RE: DRAFT REVIEW Overland Connection Conveyor,  
Cottonwood/Wilberg Mine, PacifiCorp,  
ACT/015/019-94G, Emery County, Utah

RE: Draft Review of Amendment 94G--Construction of Overland Connection Conveyor, Conveyor Belt Portal and Diesel Access Portal, PacifiCorp, Cottonwood/Wilberg Mine, ACT/015/019-94G, Folder #2, Emery County, Utah

**RE: OVERLAND CONVEYOR AMENDMENT APPROVAL CONDITIONS, PACIFICORP,  
COTTONWOOD/WILBERG MINE, ACT/015/019, FOLDER #3, EMERY COUNTY,  
UTAH**

RE: Second Amendment (94G) Review, Overland  
Conveyor, Cottonwood Mine, PacifiCorp,  
ACT/015/019, Working File, Emery County, Utah

FIGURE 5

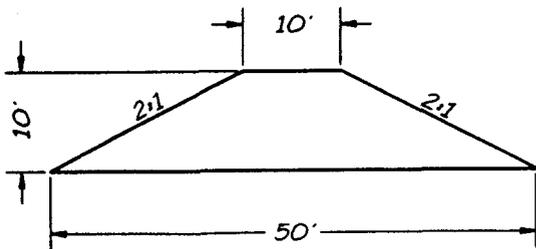
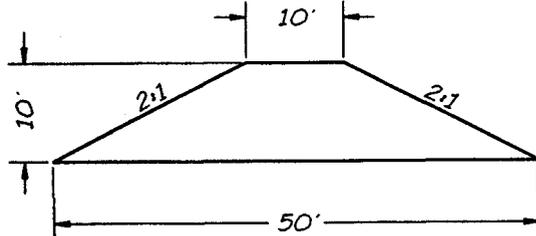
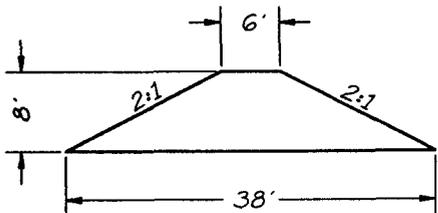
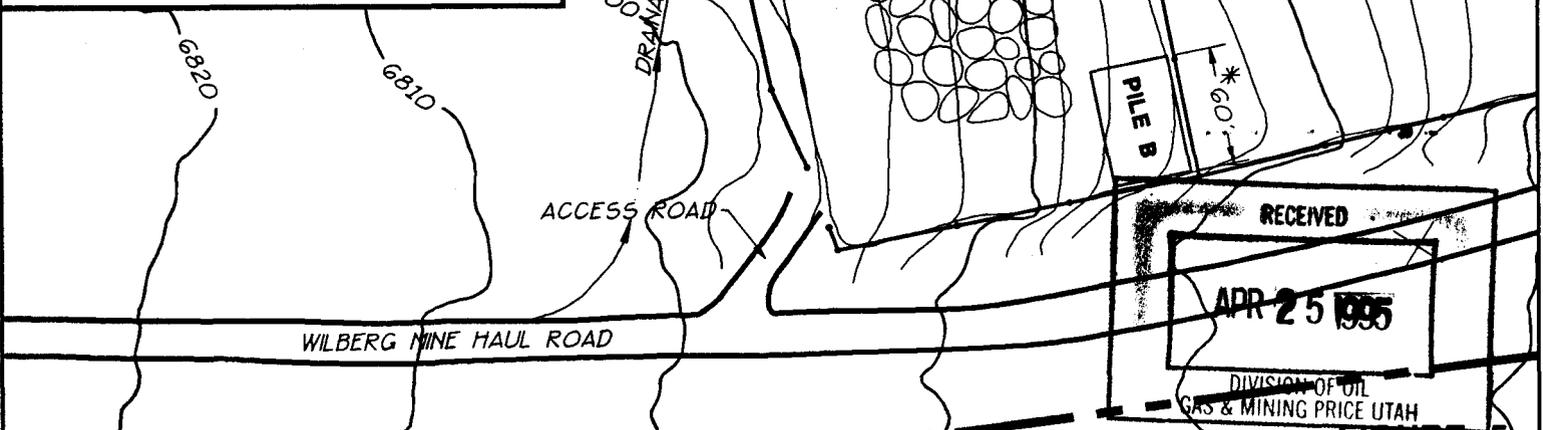
- 1) **R645-301-411.141**, Cultural and Historic Resources Maps. The permittee must submit for inclusion in the permit a map of the entire Johnson Mine site on the Cottonwood Fan Portal Surface Facilities Map, Plate 3-16A.
- 2) **R645-301-230** Side slopes of topsoil stockpiles must be decreased to at least 2h:1v.

The permittee topsoil stockpile designs for stockpiles A, B and C depict 1.5h:1.0v side slope. These must be decreased to at least 2.0h:1.0v side slopes.

- 1) Cottonwood Fan Portal Surface Facilities Map, Plate 3-16A, updated to show the extent of the Old Johnson Mine.
- 2) Figure 5, revised to reflect 2:1 side slopes on the soil storage piles.
